AGENDA
CITY OF KENTWOOD PLANNING COMMISSION
TUESDAY, NOVEMBER 23, 2021
KENTWOOD COMMISSION CHAMBERS
4900 BRETON AVENUE
7:00 P.M.

Case#34-21 – Union @ Silver Station – Site Plan Review for an Apartment Development
– located at 5844 Division Ave SE

REQUEST: Site Plan Review for a 152-unit apartment development

To: Kentwood Planning Staff
From: Brad Boomstra, P.E.
City Engineer
Date: October 29, 2021
Re: **Union @ Silver Station Apartments**
5844 Division Avenue
41-18-31-352-053
Review of Site Plans Received 10-25-2021

OVERALL
SITE PLAN

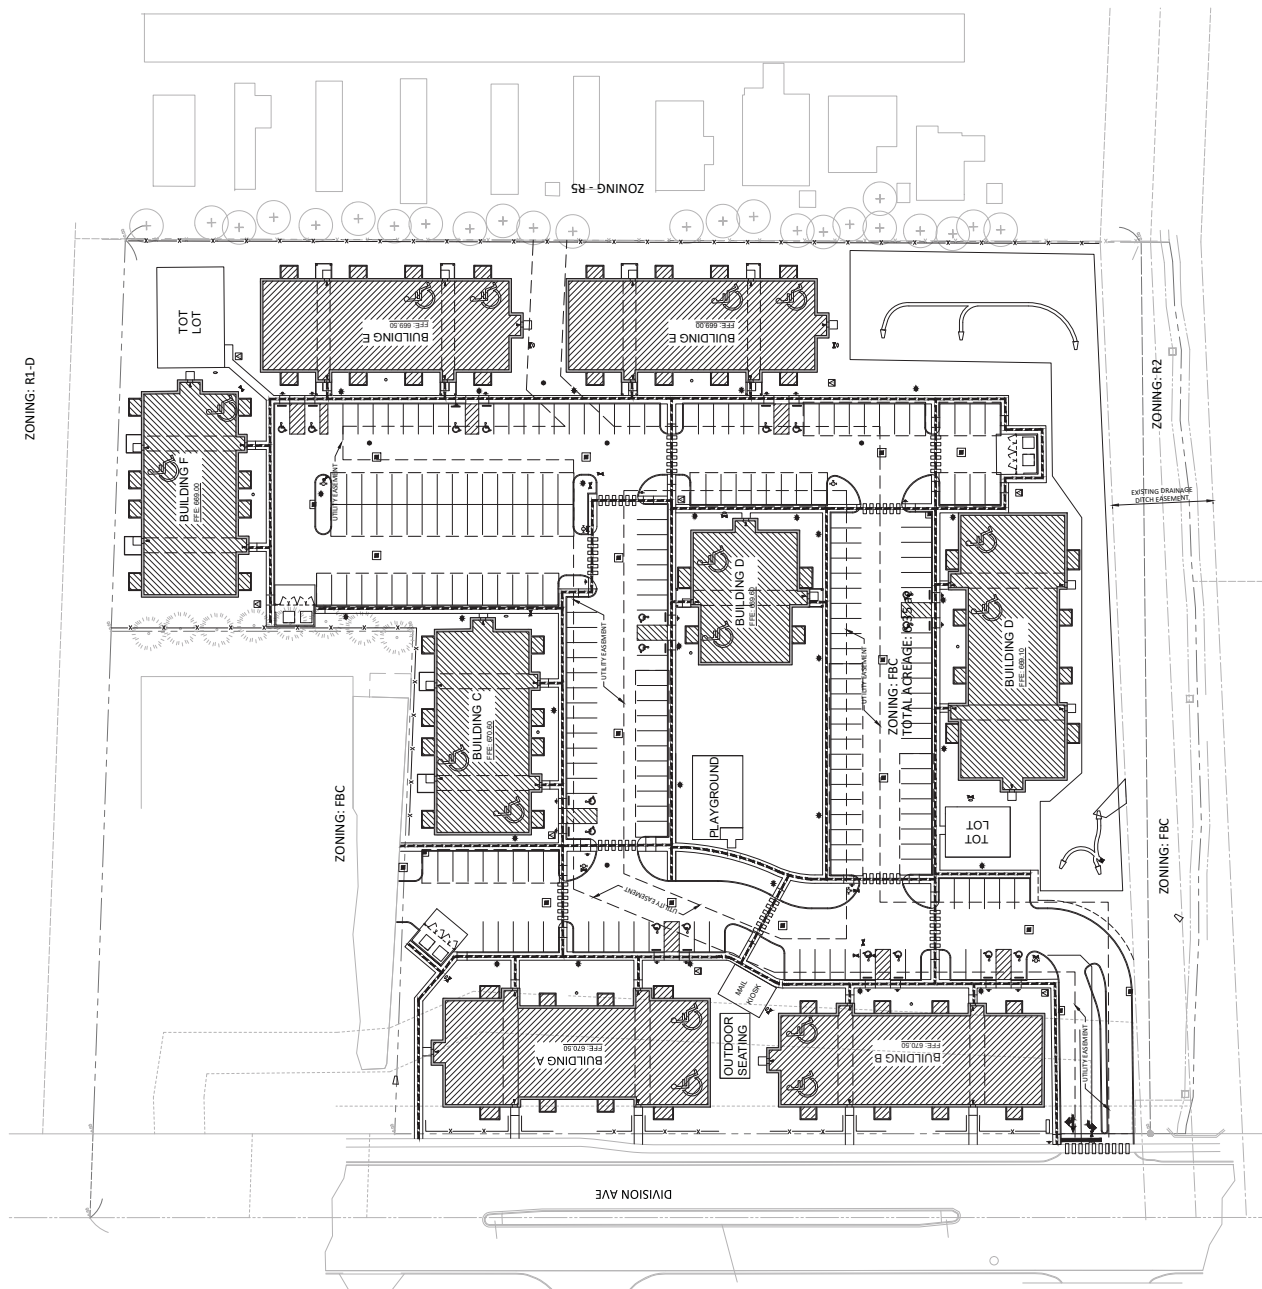
Golder stated the development is accessed from Division Avenue on the southern edge of the site. This driveway aligns with the auto sales drive driveway across Division Avenue (City of Wyoming). In addition, it is possible that the apartment development can be accessed through the Family Dollar parking lot. When the Family Dollar was developed in 2000, it was part of an overall PUD development that included the site for the proposed Union at Silver Station Apartments. Cross access between the two parcels was a condition of the approval of the original development; a cross access easement was recorded. The original cross access easement is located 60' from the proposed cross access for the apartment development. The easement will have to be amended in order to allow cross access between the uses.

Golder stated the one thing she questioned was the sufficiency of open space in the plan. The proposed development includes a clubhouse, a dog park, a playground, and an “amenity space”. The applicant must detail what is included in the amenity space and playground. She stated with 28 three bedroom apartments, there are likely to be a number of children living within the development; the location of play area/open space is limited within the development.

4. The applicant has been asked to show the existing vegetation on the mobile home property in order to determine where additional landscaping should be provided along eastern edge of the apartment development. The plan does not indicate the species or size of the trees on the mobile home park property, making it difficult to determine the amount and type of landscaping needed for screening between the uses.

5. The sidewalk ends at the edge of the parking lot near Building D. It must be extended to provide another access to Division Avenue on the south side of the driveway.

- Per comments from Planning staff and Commission members, the Building E buildings have been pushed as far to the west as possible away from the east property line that abuts with Brentwood Village. In addition, a 6ft tall wood shadow box fence has been added along the property line and landscaping has been added to help screen the buildings from the residential property. In addition, the a/c units have been moved to the west side of these buildings in order to minimize noise bleed over.

- Per comments from Planning staff and Commission members, the Building D located in the middle of the development has been cut in half in order to provide additional green space for the community and reduce the density of the development. This green space has been left relatively open to allow for flexibility of the resident's use. The southern Building D has been revised to be 3 stories to maintain the unit count.

- Per comments from Planning staff, the carports that were located in front of the buildings and patios have been relocated to areas away from the front of the buildings or moved to not be directly in front of the buildings.
